SYNTHETIC TURF SECTION

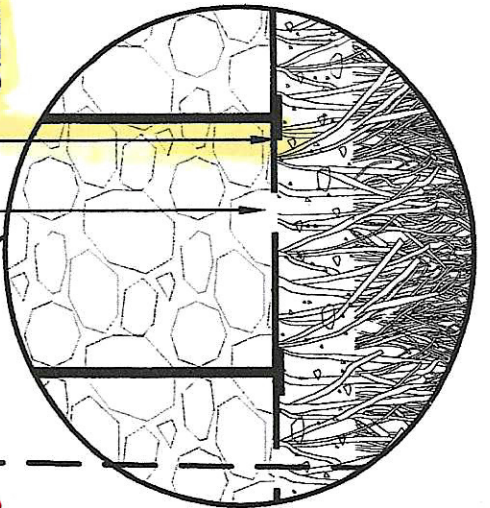
Not HST?

Not needed

Why's?

Why?
